Access Compliance Report

Public Rights-of-Way

Intersection ID: 31537	Main Street: CARLEEN_WAY_DR	Cross Street: GRIER_SPRINGS_LN	Location: NW
ADA ID: 67B7E68F104B	Ramp Type: PerpDiag	Initial Pass/Fail: Fail	Overall Compliance: No
Severity Score: 12.5			
Codes/Mitigation Info/Possible Solution		Field Measurements/Component Compliance

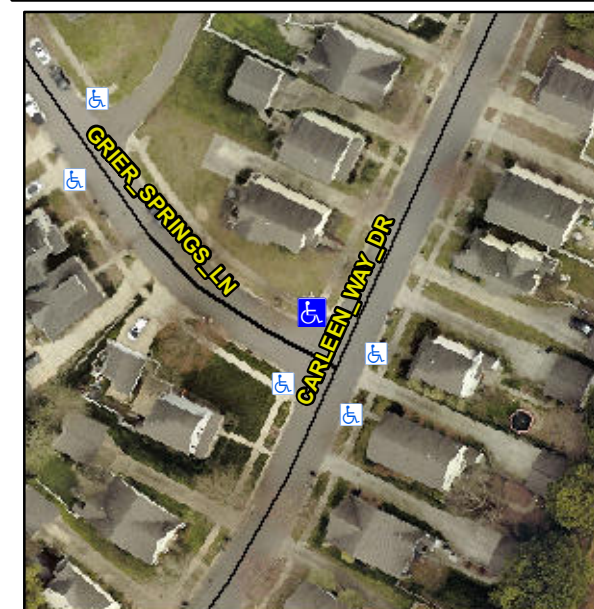
Not Found, R304.5.3

Compliance	Description	Data	Compliance	Description	Data
N/A	Ramp Length (in)	55.5	Yes	Ramp Slope (%)	7.1
Yes	Ramp Width (in)	48.5	No	Ramp XSlope (%)	5.6
N/A	Flare Type LT	N/A	N/A	Flare Type RT	N/A
N/A	Flare Slope LT (%)	N/A	N/A	Flare Slope RT (%)	N/A
N/A	Flare Traversable LT?	N/A	N/A	Flare Traversable RT?	N/A
N/A	Landing Length (in)	N/A	N/A	DWS Provided?	N/A
N/A	Landing Width (in)	N/A	N/A	DWS Contrast?	N/A
N/A	Landing Slope (%)	N/A	N/A	DWS Length (in)	N/A
N/A	Landing X Slope (%)	N/A	N/A	DWS Full Width?	N/A
N/A	Landing Curb? (Y/N)	N/A	N/A	DWS Offset (in)	N/A
N/A	Shared Landing?	N/A			
N/A	Gutter Ponding?	N/A	N/A	Gutter Slope (%)	N/A
N/A	Gutter Lip Ht (in)	N/A	N/A	Gutter X Slope (%)	N/A
N/A	Painted X Walk1?	No	N/A	Painted X Walk2?	No
	X Walk 1 Direction	To SW		X Walk 2 Direction	To SE
N/A	X Walk 1 Width (in)	N/A	N/A	X Walk 2 Width (in)	N/A
	X Walk 1 Slope (%)	0.9		X Walk 2 Slope (%)	3.5
	X Walk 1 X Slope (%)	6.6		X Walk 2 X Slope (%)	2.5

N/A	Ramp inside XWalk1?	N/A	N/A	Ramp inside XWalk2?	N/A
	Road Slope (%)	4.8	N/A	Clear Space?	N/A
	Road X Slope (%)	5.4	N/A	Clear Space to XWalk (in)	N/A
N/A	Any Obstructions?	N/A	N/A	Storm Grate/Utility Hazard?	N/A
	Obstruction Type			Storm Grate/Utility Type	
		N/A			N/A
		Yes		Surface Condition? (G/P)	Good

Remove & Replace Curb Ramp With Two New Directional Ramps or Equivalent.
